REQUEST FOR INFORMATION **DATE:** May 03, 2017 **NO.:** RFI-526

Project Name: 15051-Webster University Interdisciplinary Science Building Project No.: 15051

Subject: Railing height clarification

1 WEST WALL & RAIN GARDEN RAILING SECTION
3" = 1'-0"

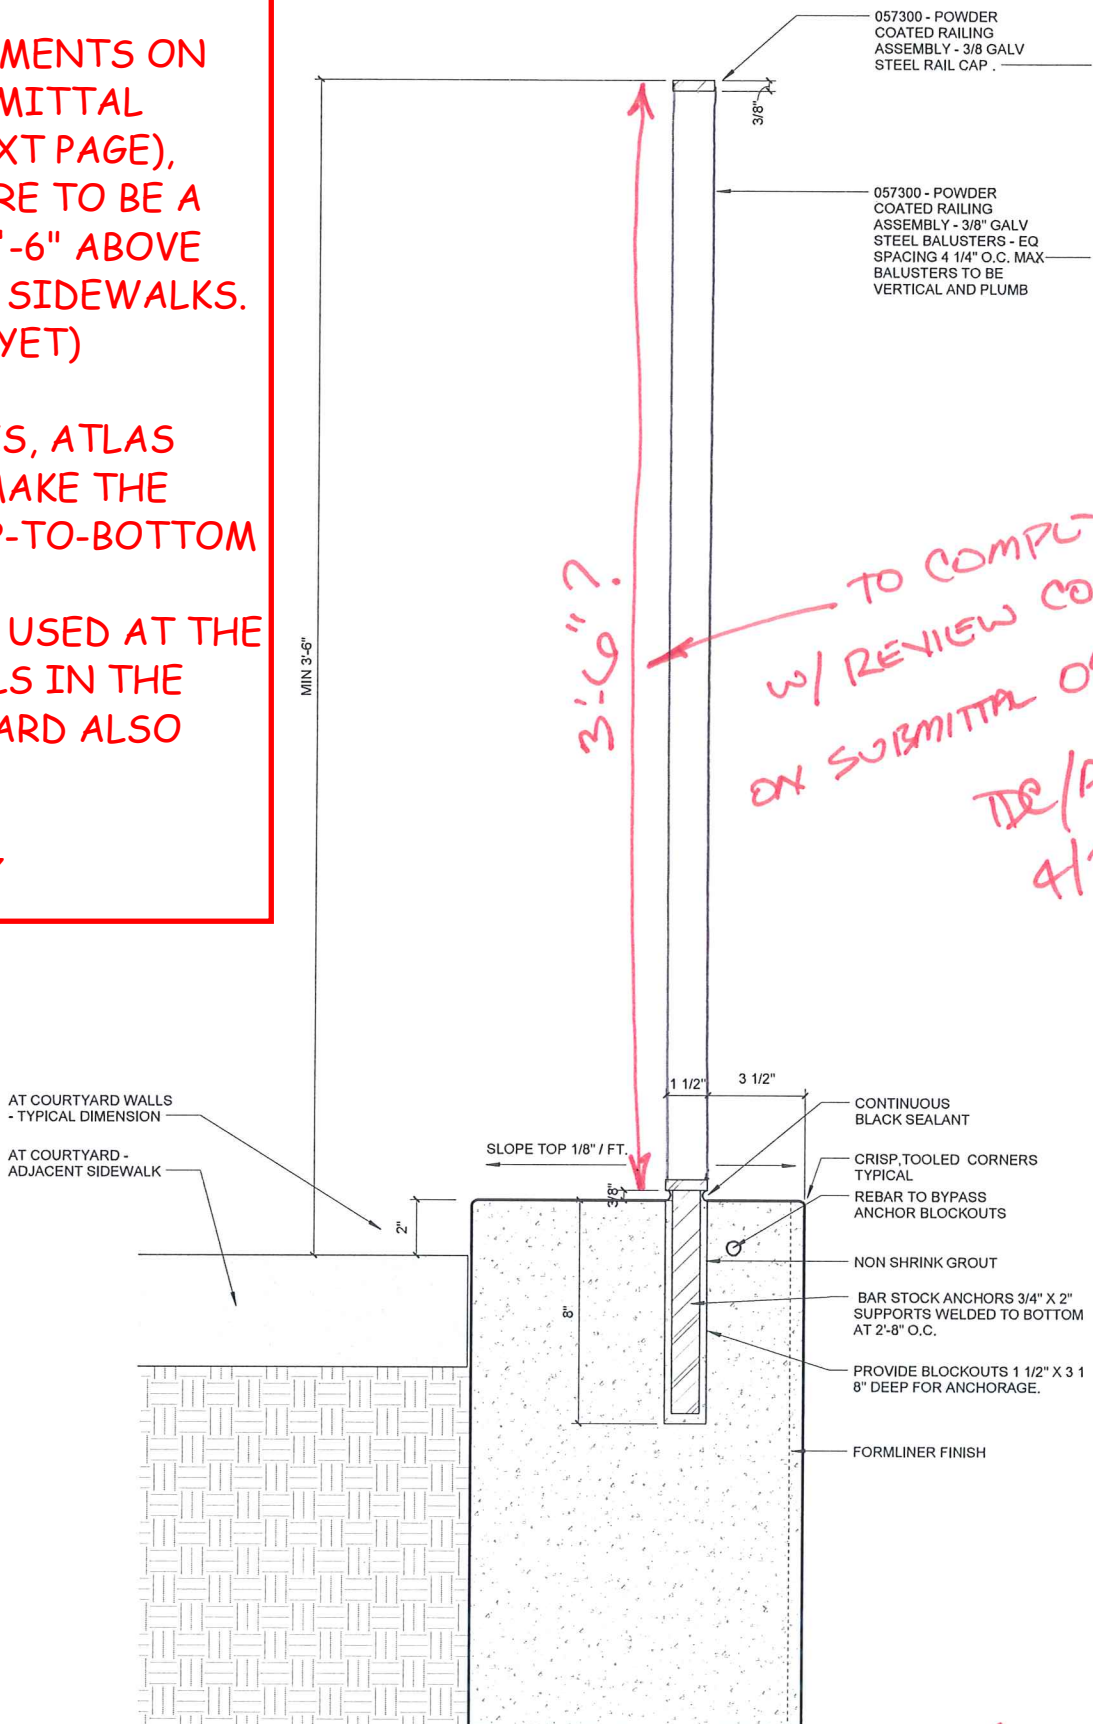
The comments on page 2 of the reviewed submittal 055213-009 (see attached) read that "The tops of all railings are to be a minimum of 3'-6" above adjacent sidewalks".

Due to construction tolerances and imperfections there is concern Atlas proposes to fabricate these handrails taller to confirm design intent can be met.

This condition also applies at the 3'-6" rails in the mechanical (east) courtyard on A0101.A. Also, at this location please confirm if the height should be based off of the top of the wall as there is no sidewalk.

TWO QUESTIONS:

1) PER THE COMMENTS ON REVIEWED SUBMITTAL 055213-009 (NEXT PAGE), THESE RAILS ARE TO BE A MINIMUM OF 3'-6" ABOVE THE ADJACENT SIDEWALKS. (NOT IN PLACE YET)

TO INSURE THIS, ATLAS PROPOSES TO MAKE THE RAILS 3'-6' TOP-TO-BOTTOM

2) CAN THIS BE USED AT THE 3'-6" HIGH RAILS IN THE MECHANICAL YARD ALSO (A0101.A)?

As discussed with Atlas, make top of the railings above the concrete wall to be 3'-5" from top of the concrete wall - for both the rails. With the sidewalk being +/- 2" below the top of the concrete walls, this should give an 1" of construction tolerance for sidewalk levels.
